Project	IEEE 802.16 Broadband Wireless Access Working Group < http://ieee802.org/16 >
Title	MBS AES-CTR Test Vector and Test Program Changes
Date Submitted	2005-03-10
Source(s)	JUNHYUK SONG, JICHEOL LEE, YONG CHANG Voice: +82-31-279-3639 Samsung Electronics junhyuk.song@samsung.com
Re:	
Abstract	MBS AES-CTR Test Vector
Purpose	Per C802.16e-05/047r1, MBS AES-CTR Test Vector and figure change
Notice	This document has been prepared to assist IEEE 802.16. It is offered as a basis for discussion and is not binding on the contributing individual(s) or organization(s). The material in this document is subject to change in form and content after further study. The contributor(s) reserve(s) the right to add, amend or withdraw material contained herein.
Release	The contributor grants a free, irrevocable license to the IEEE to incorporate material contained in this contribution, and any modifications thereof, in the creation of an IEEE Standards publication; to copyright in the IEEE's name any IEEE Standards publication even though it may include portions of this contribution; and at the IEEE's sole discretion to permit others to reproduce in whole or in part the resulting IEEE Standards publ

Figure 137a—MBS MAC PDU Ciphertext payload format

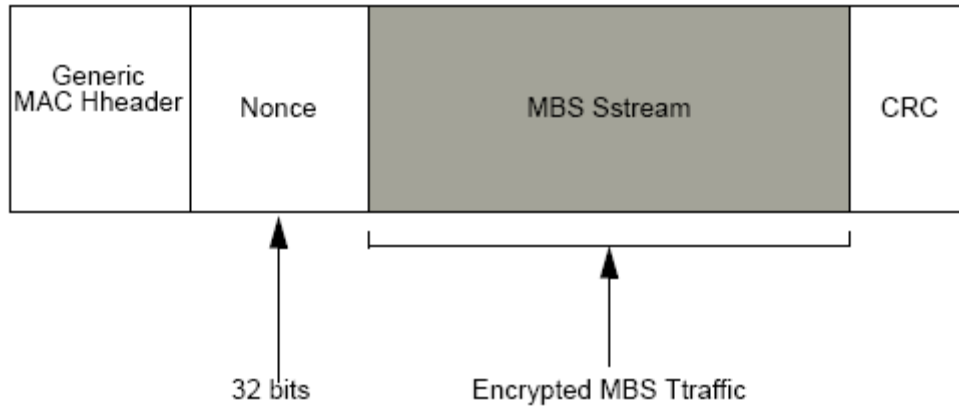
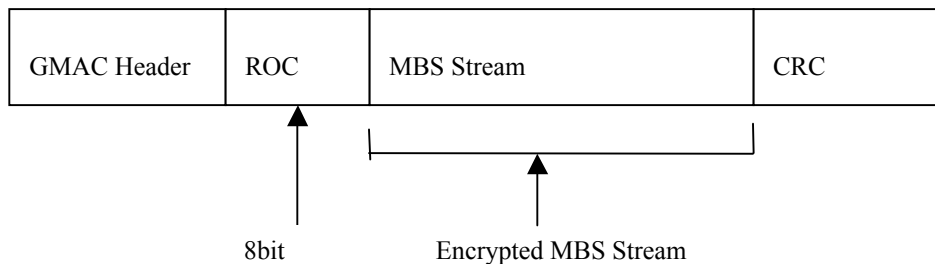
Per decision of last meeting, Data encryption with AES in CTR mode is newly proposed and D6 text is changed.

According to newly proposed usage which make use of ROC(roll-over-counter) and Frame Number, there are two things that should be changed together like followings:

1. Figure 137a MBS MAC PDU Ciphertext payload format
2. MBS AES-CTR Test Vector and test program

[Change Figure 137a.]
